Report No. FRA-OR&D 75-41

REVIEW OF PROPOSED SPECIFICATIONS RELATING TO THE SHIPMENT OF ETHYLENE IN TANK CARS AT CRYOGENIC TEMPERATURES

FINAL REPORT

Figure 2 DISCRIMINATING POWER OF FIXED AVERAGE PRESSURE RISE PER DAY SPECIFICATION TO ESTABLISH ADEQUATE HOLDING TIME - 113 SERIES CARS

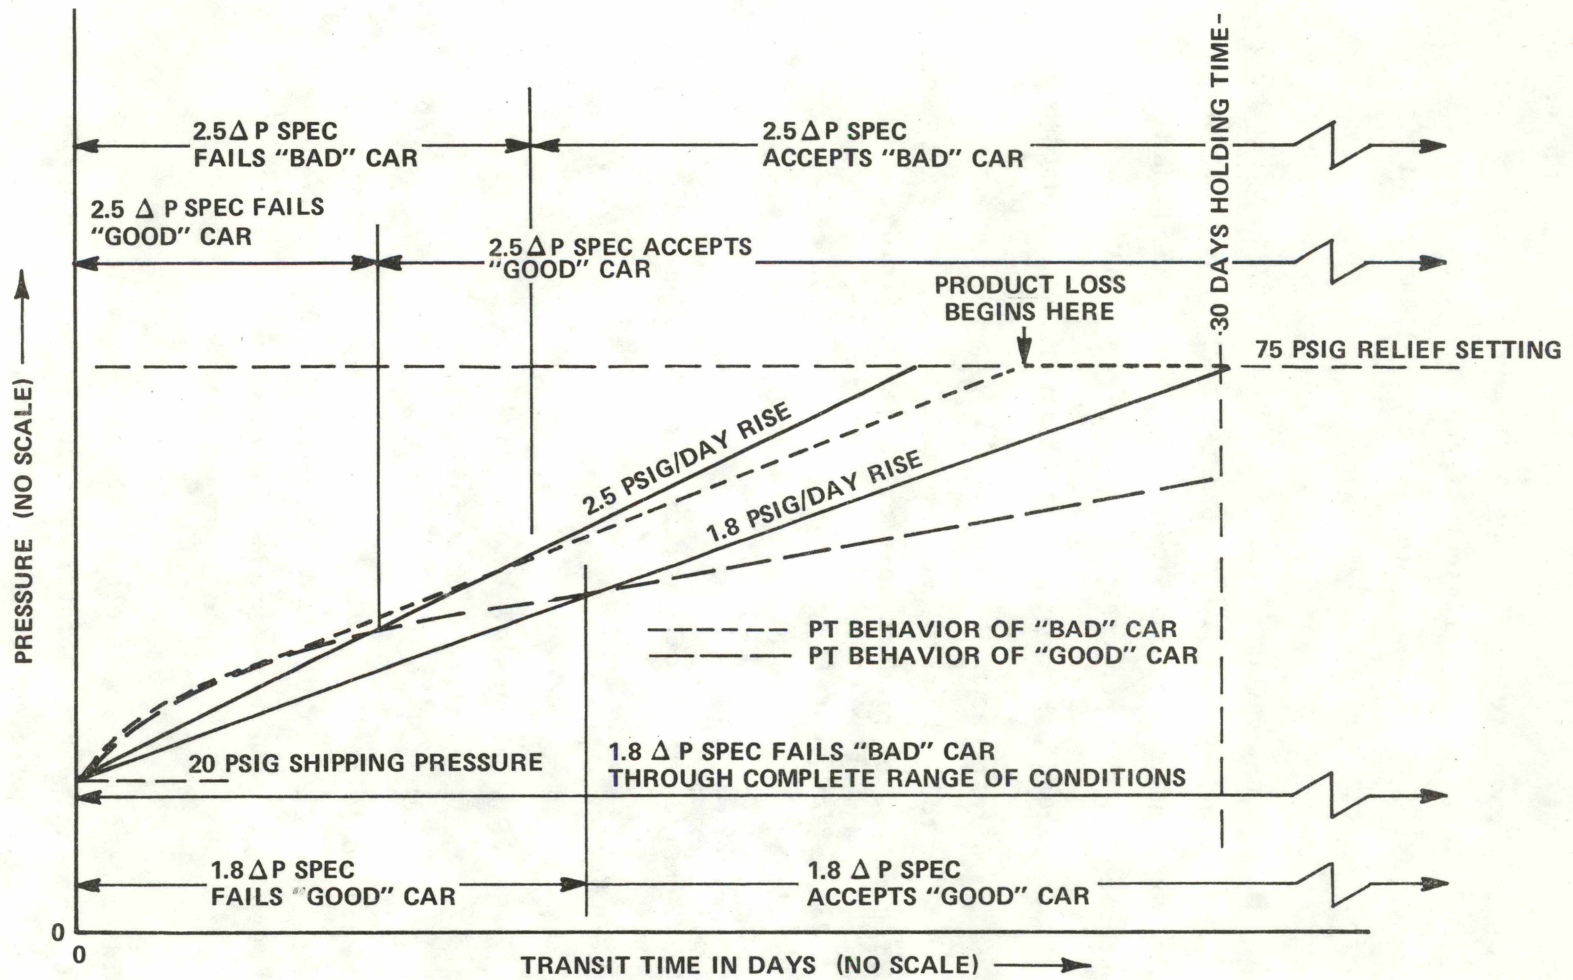
The proposed specification uses a straight line 2.5 psig/day average pressure rise over the period of transit at the accept or reject criterion. The actual pressure versus time behavior of the car will be significantly non-linear. Initial pressure rise with time will be high due to heat inputs from a "warm" car, and due to the high temperature difference (driving force) between the atmosphere and the lading. With the passage of time, the temperature difference, hence heat transfer, reduces and so does the rate of pressure rise. There is a counter-force in that pressure increases exponentially with increase in internal energy, which will cause a reversal of the pressure rise trend. However, the safety-relief valve setting constitutes the upper limit to pressure rise inasmuch as above that pressure the valve will discharge thus maintaining tank pressure between the limits of 60 to 75 psig. It follows that the maximum average pressure rise possible on a shipment in a 113D120W car shipped at 20 psig is only (1) $\frac{(75-20 \text{ psig})}{30 \text{ days}} = 1.83 \text{ psig/day}$ for a transit time of 30 days, the specified acceptable minimum holding time. Detection cut-off for the 2.5 psig criterion is

$$(2) \quad \frac{(75-20)\text{psig}}{2.5 \text{ psig/day}} = 22 \text{ days for 113D120W cars at maximum shipping pressure}$$

$$(3) \quad \frac{(75-10)\text{psig}}{2.5 \text{ psig/day}} = 26 \text{ days for 113C120W cars at maximum shipping pressure}$$

Thus, for any trip exceeding 22 days, all 113D cars would pass regardless of product loss or true condition. Hence, for long duration trips where most concern is required, the criterion fails. Conversely, a shipper whose transit times are very short may repeatedly fail the test with a "good" car. Thus, the 2.5 psig/day criterion is leveraged the wrong way. The application of a 1.8 psig/day criterion for 113D cars, and a 2.1 psig/day criterion for 113C cars would eliminate the acceptance of "bad" cars, i.e., cars that would vent before 30 days given the 90°F ambient temperature condition. However, this would tend to accentuate the rejection of good cars involved with short trips. The effect is illustrated in Figure 2.

Figure 3 CONCEPTUAL IN-TRANSIT PRESSURE RISE SPECIFICATION

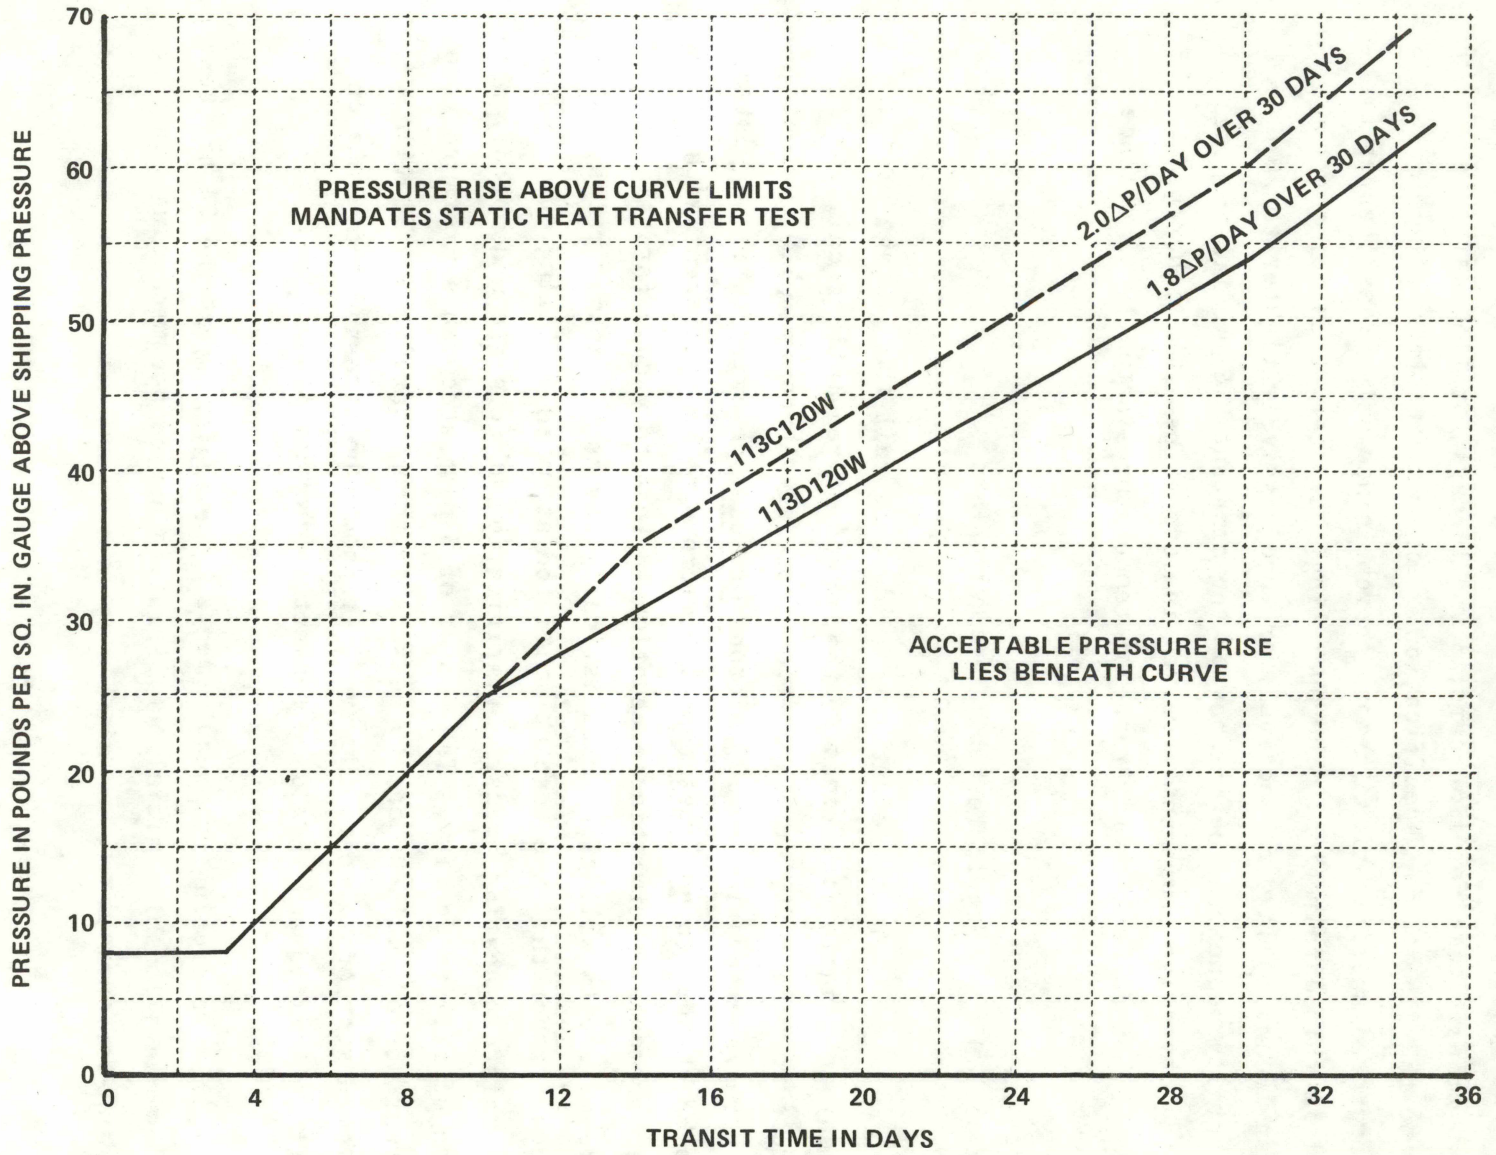
It would be desirable to develop accept/reject criteria that would more closely follow the inherent temperature-pressure-time characteristics of ethylene. As an interim measure an alternate in-transit pressure rise specification is proposed in Figure 3.

The conceptual specification operating characteristic between 3 and 10 days transit time for 113D cars, 3 and 14 days for 113C cars, is identical to the 2.5 psi/day specification. For transit times 3 days or less the proposed specification is more lenient since only gross changes are meaningful in this data region. The operating characteristics for the two curves past 10 and 14 days respectively are progressively tighter to 30 days to substantially reduce the deficiency of the constant 2.5 psi/day proposal in detecting defective equipment involved in long trips. The inherent deficiency of not correcting for range of temperatures actually experienced remains.
